DESCRIPTIVE REPORT
(HYDROGRAPHIC)

Type of Survey Hydrographic
Field No. FA-5-1-78
Office No..... H-9737

LOCALITY
State California
General Locality Estero Bay
Locality Morro Bay

PACIFIC MARINE CENTER
VERIFIER'S REPORT

*Charted delineation
of channels thru
mud flats*

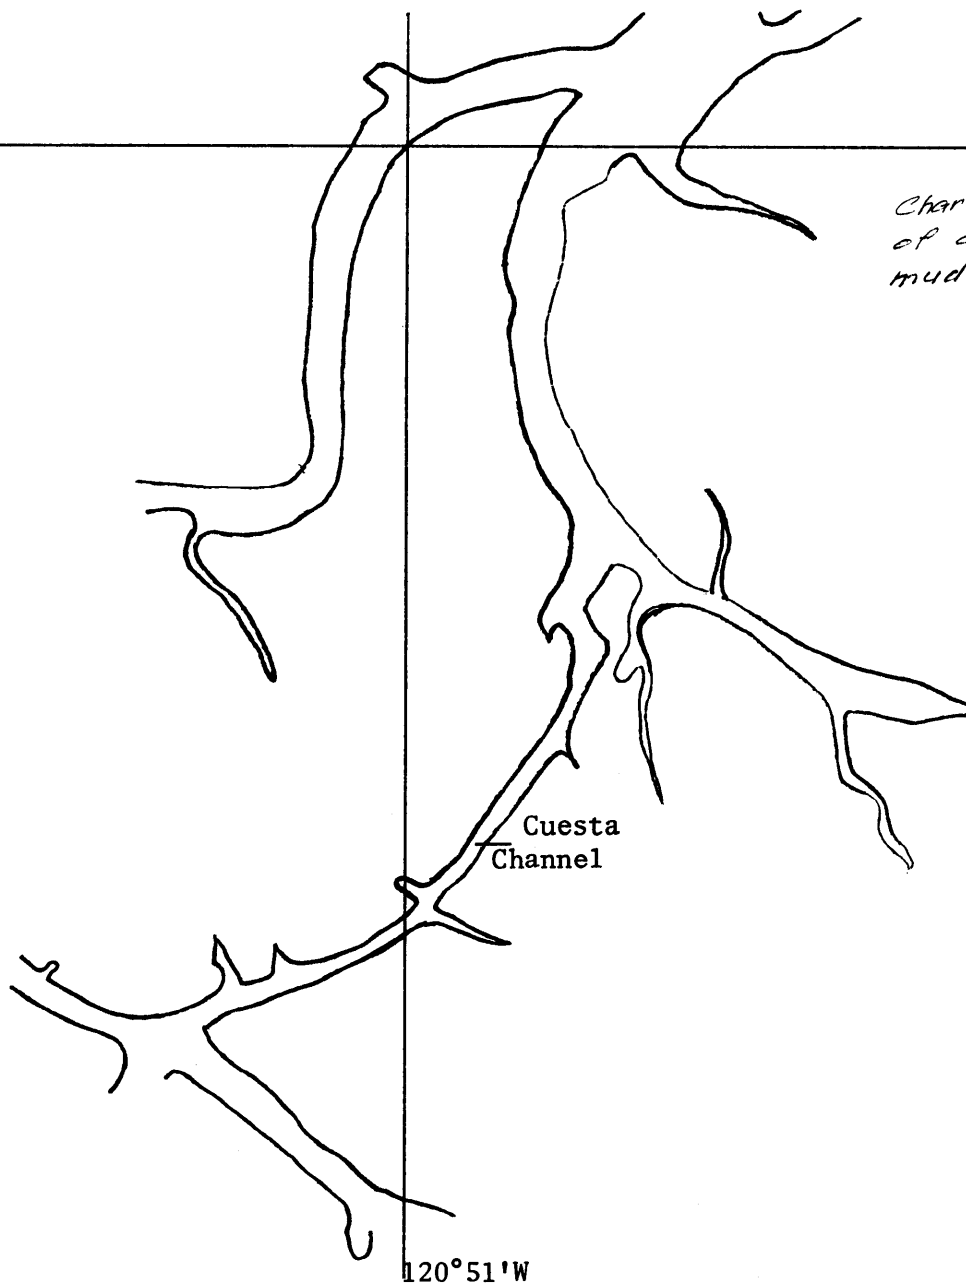
All buoys, both navigational and mooring, were located by detached ✓
positions. Numerous mooring buoys were located throughout Morro Bay
and are plotted on the field smooth sheet. *Wh & Orange "No Wake" buoy #5
was not located with a D.P. & not shown on boat sh.*
The buoy was plotted from two references in the sdg vol. 7ps
The following is a comparison with Light List Volume III Pacific Coast
and Pacific Islands, 1978. As mentioned before, Lighted Buoy "2" was
not in place for most of this survey and was placed as listed in Section L.
Lighted Buoy "3" is located in slightly shoaler water at 17 feet MLLW,
than the reported 21 feet. Lighted Buoy "4", in the PSR shoaling region,
is located in 14 feet MLLW as compared to the listed 18 feet. Lighted
~~Daybeacon~~ "8" is listed to be in 25 feet of water while it is actually
in 20 feet at MLLW.

The main channel at Lat. 35°21'54"N Long. 120°52'00"W was found slightly shoaler than the charted depths with the minimum depth in the area of ~~14~~ ¹¹ feet, compared to the charted 3 1/2 fathoms. The ^{main} channel leading to White Point Marina was found to have a least depth of 12³ to 12⁷ feet compared to the charted depth of 2 1/2 fathoms. A deep point off Fairbank Point exists at a comparable depth to the charted depth. The channel listed as abandoned in the southern portion of Morro Bay, Cuesta Channel, was actually found to be the main channel to use to reach the south end of the bay. ✓

Copy of a portion of H-9737 boat sheet
with the location of mooring buoys
not plotted on the smooth sheet.
Mooring buoys are shown with a circle

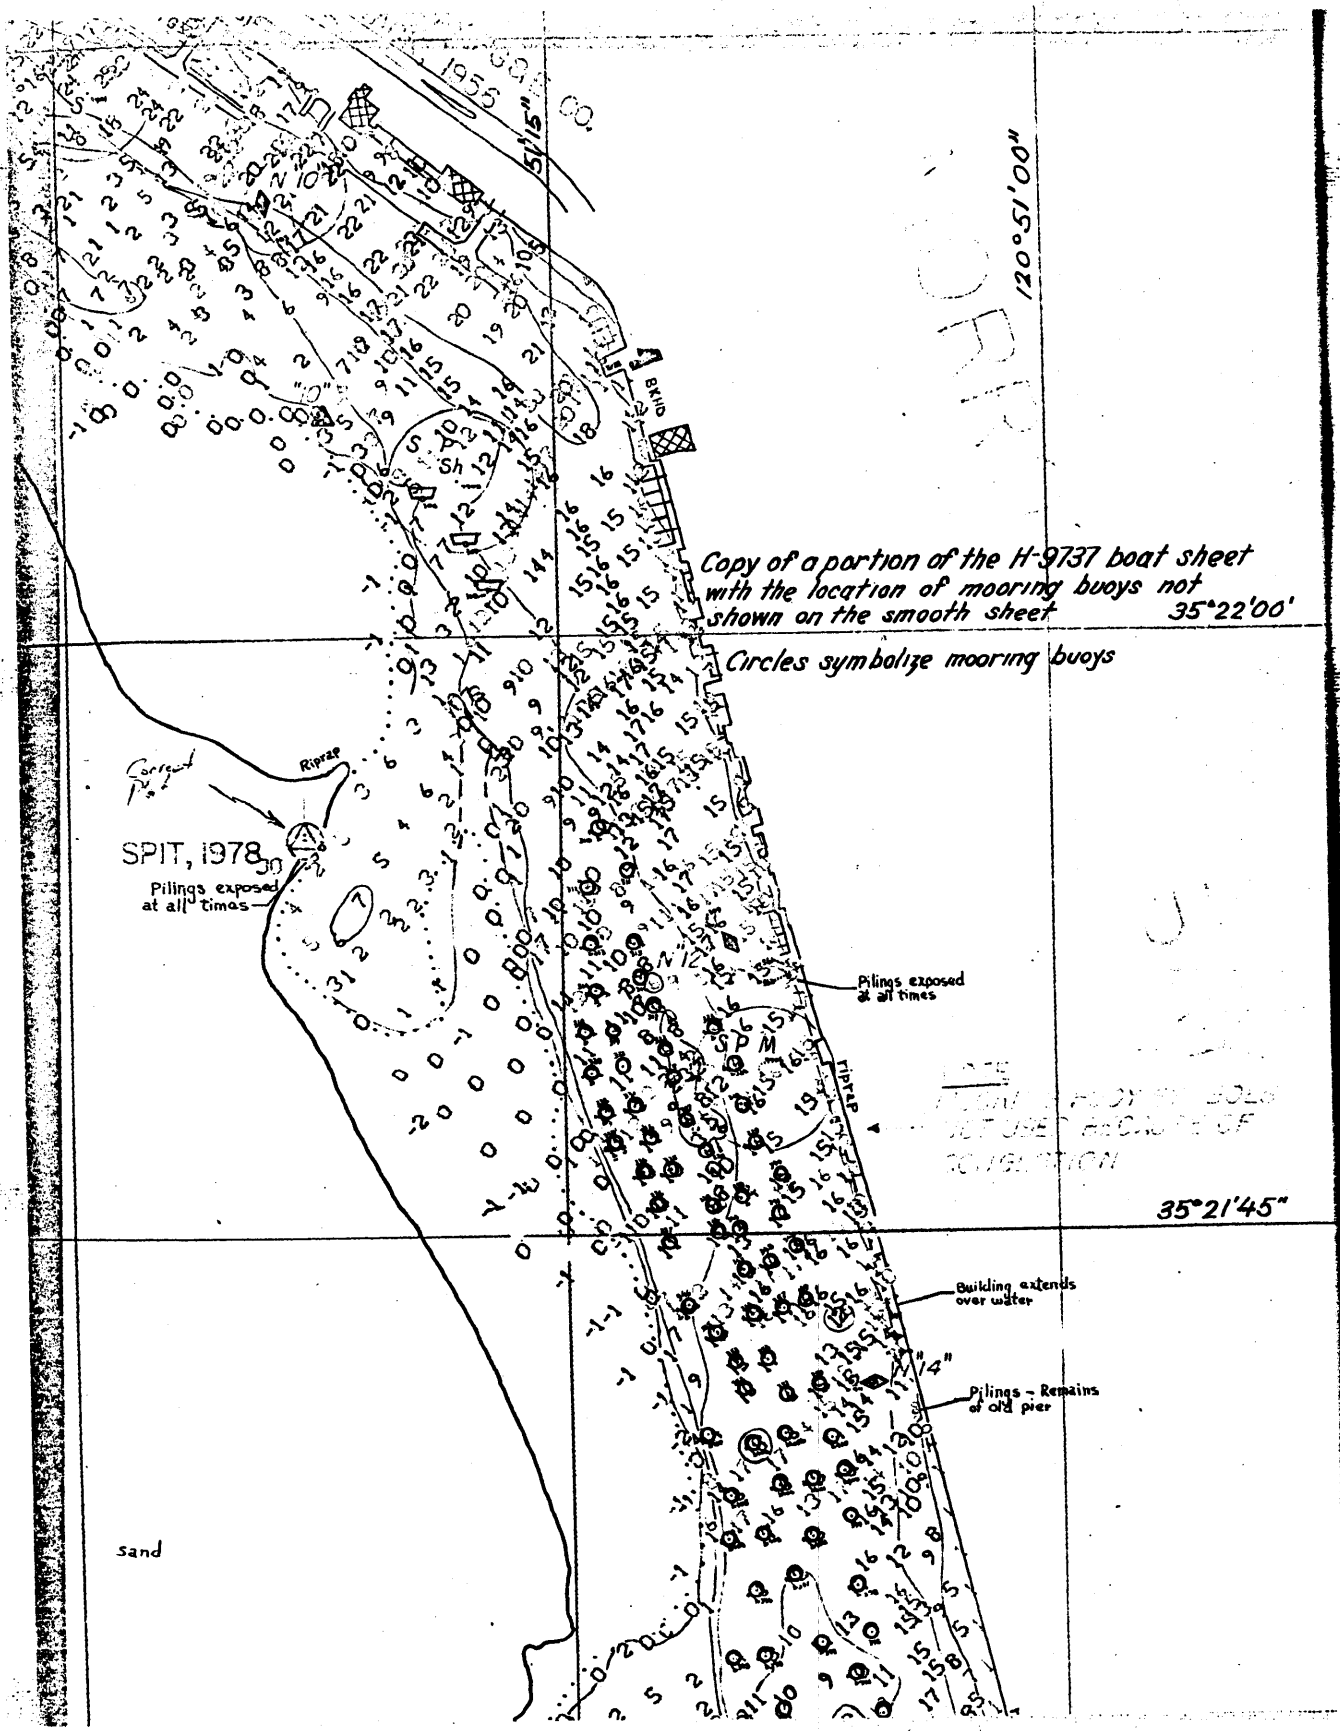
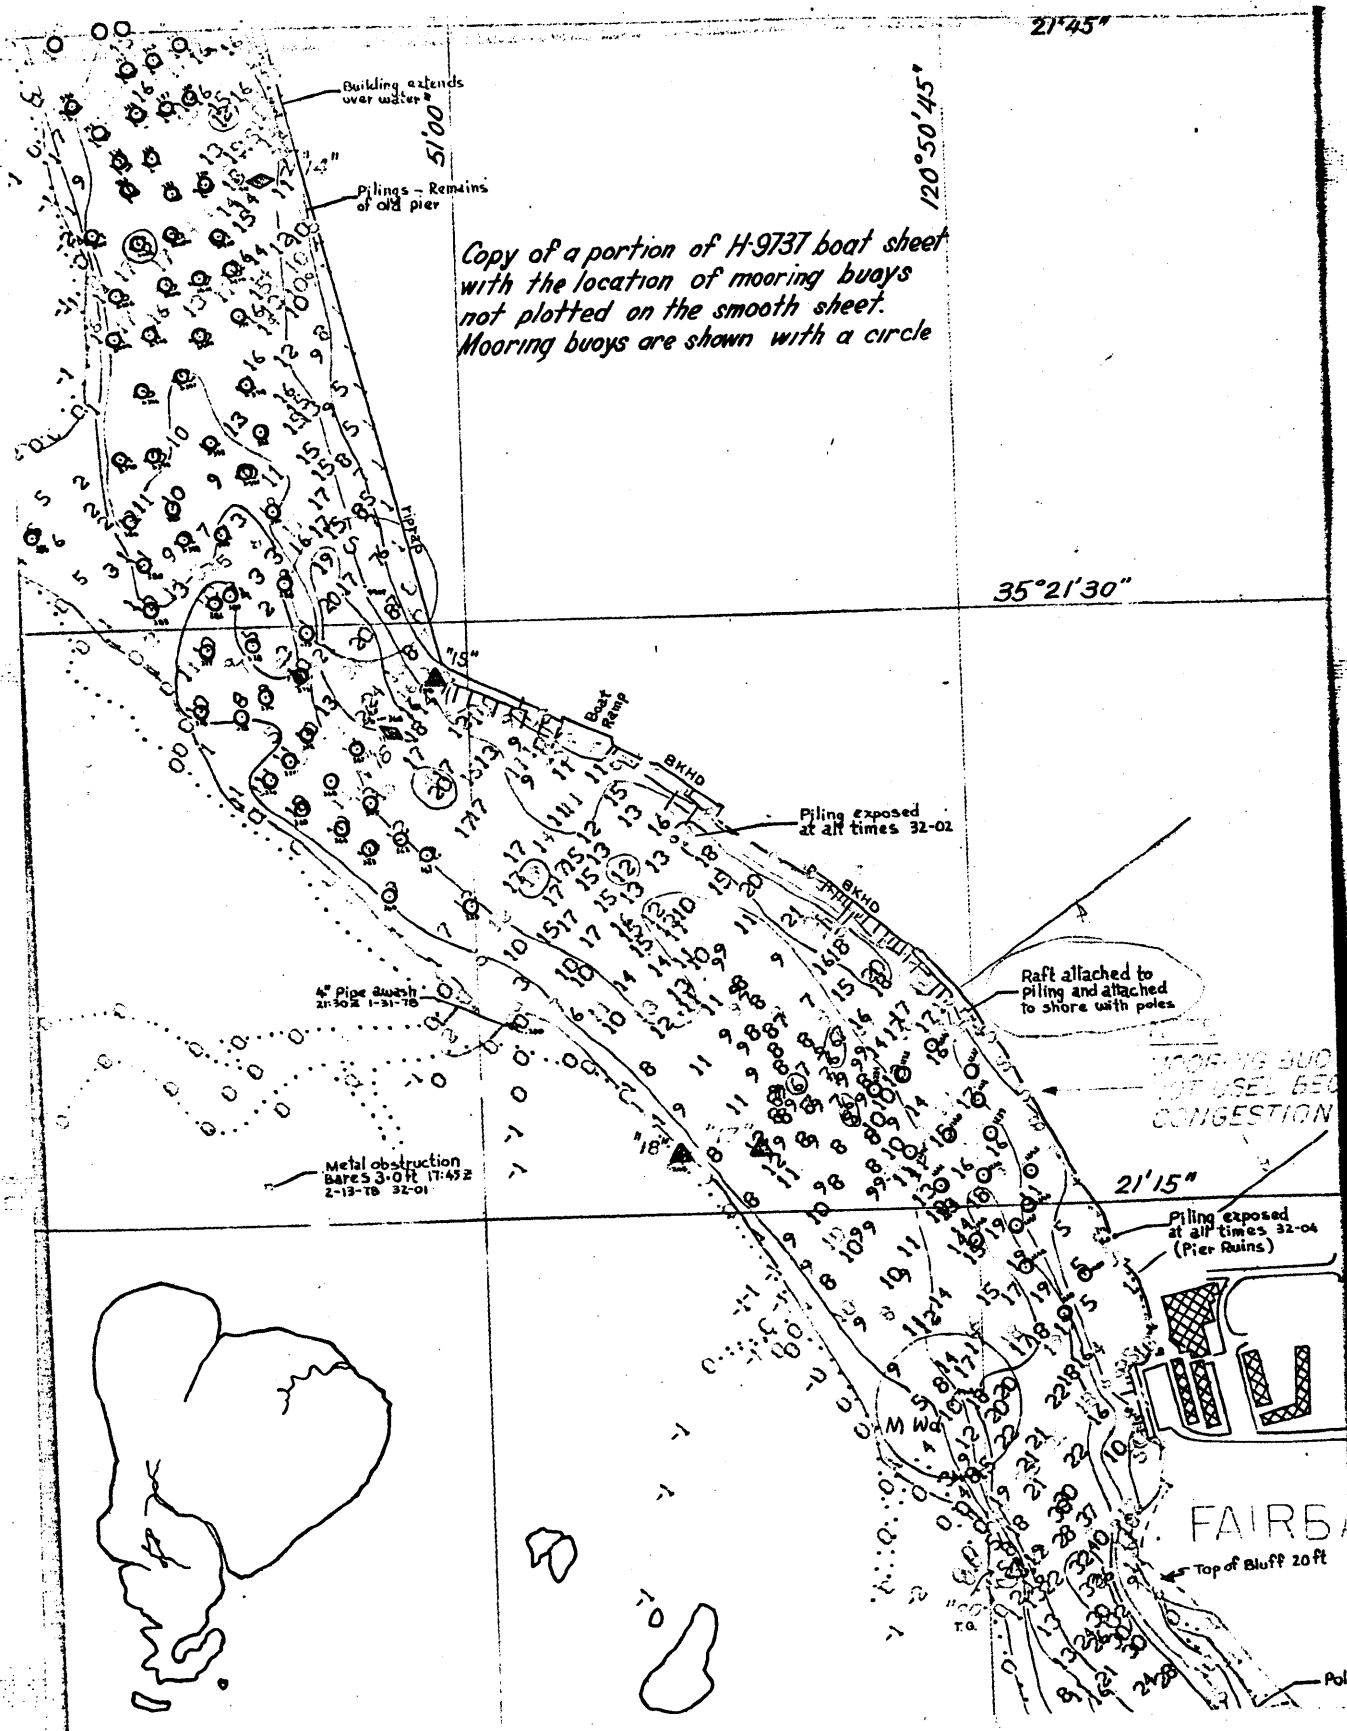
Because of congestion, numerous mooring buoys were not plotted on the smooth sheet during verification. Notes on the smooth sheet attest to this and identify the general location of the mooring buoys. A section of the boat sheet, containing the plotted boat sheet positions of the mooring buoys, has been inserted in the Descriptive Report during quality control inspection.
